September 30, 2019

Re: Proposed Cooper Park Expansion

Figure 1 - Proposed Cooper Park expansion area, with current bike path connection in blue

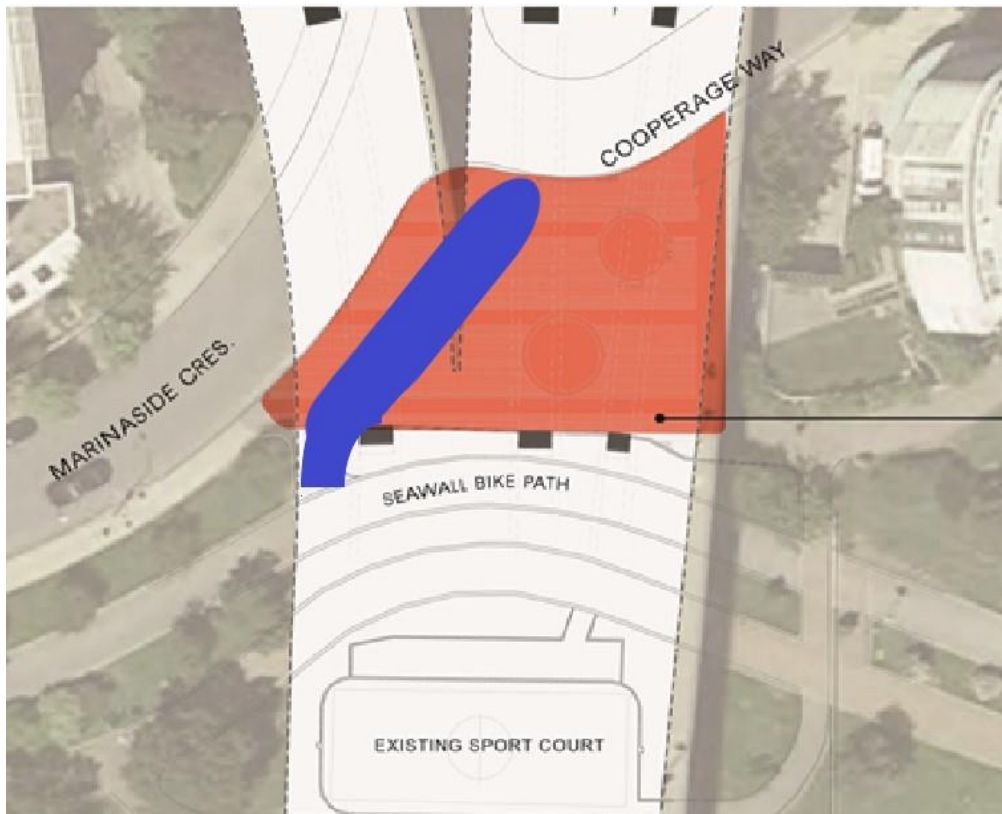
- 1) The current bike path connection between the Cambie Bridge northbound MUP and the Seawall bike path is shown in blue in Figure 1, from the ramp and crossing of Cooperage Way at the intersection with Marinaside Cres, to the Seawall bike path. This route connects two key protected bike lanes, and eliminating it, pushing vulnerable road users (in some cases families with children) into the roadway greatly reduces the value of these existing protected paths. There are conflicts evident today between people walking and people cycling on this short connection; some users assume it is a sidewalk, but there is no access to the Seawall walking path, only to the Seawall bike path, and in fact temporary fencing has been erected between the bike path and walking path, to stop people crossing to the walking path. As can be seen in Figure 2, the new equipment is likely to block this important cycling connection. We note the reference in the Open House concept drawings to a future bike lane along Marinaside Crescent. We agree that if this is a protected bi-directional bike lane that this could be designed as a workable solution, but it is important that the new bike lane be completed before the existing path is changed. It is not enough to rely on others for that path, in this case the City of Vancouver engineering department, as we have heard expressed by Park Board staff several times when we have raised this concern. Rather, the works must be coordinated as to timing and interconnections. That means delaying any park construction in the space until an alternate route is designed and built. Any new on-street bikeway must also include connections to the Seawall bike path, presumed to be just west of the current access point.

Figure 2 - Concept for the Playground Renewal

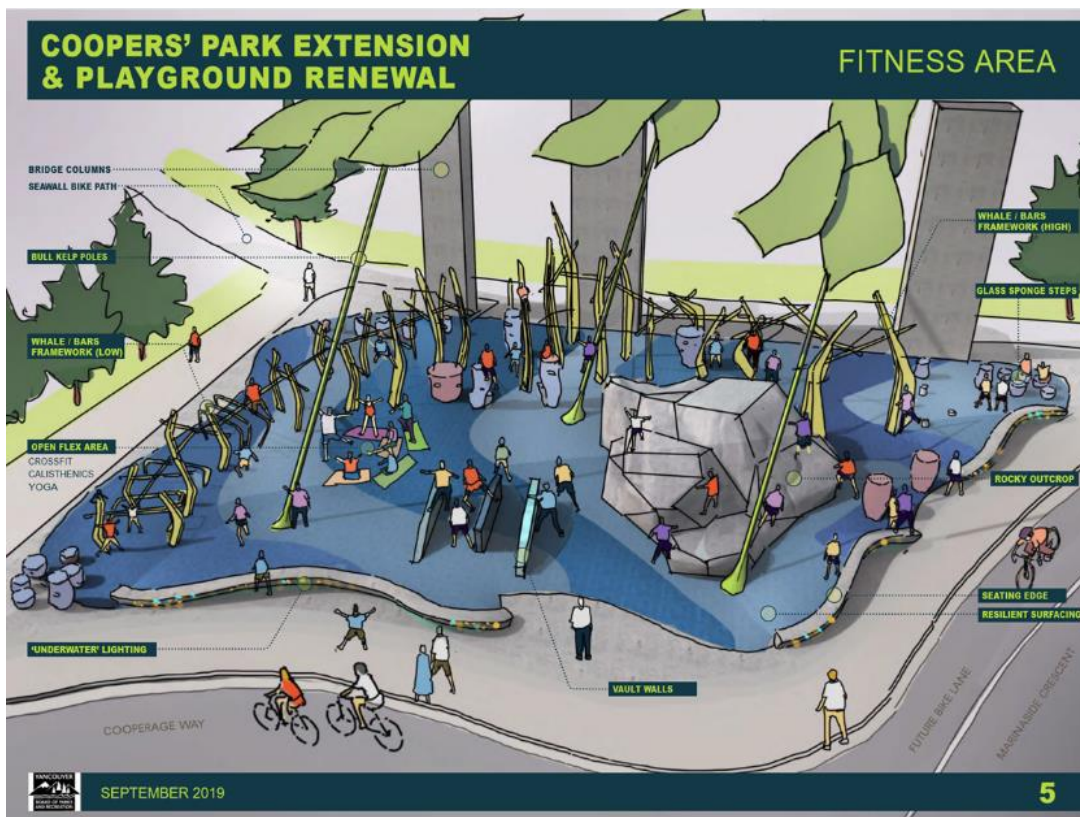
- 2) We know that today there are conflicts with people stepping into the Seawall bike path from this area, and from the sports court to the south, putting themselves and others at risk. This is made worse by the large bridge piers which obstruct visibility right next to the bike path. The recent removal of the large storage racks opened the space and added walking traffic. Adding additional people into this area is likely to make this problem worse, and the existing plantings are not enough to deter people cutting through to the south. We recommend the inclusion of low fencing, or similar design features, to direct people crossing to use the existing Seawall bike path crosswalk just east of this area, and potentially to any new bike path crosswalk on the west side of this area. If other improvements are being considered to Cooper Park immediately to the east, the problems inherent in locating a dog park immediately next to a busy bikeway should be recognized. At Charleson Park, when the Seawall bike paths were rebuilt, this was addressed with a low fence. That fence appears to work well and something similar should be included along the length of Cooper Park.
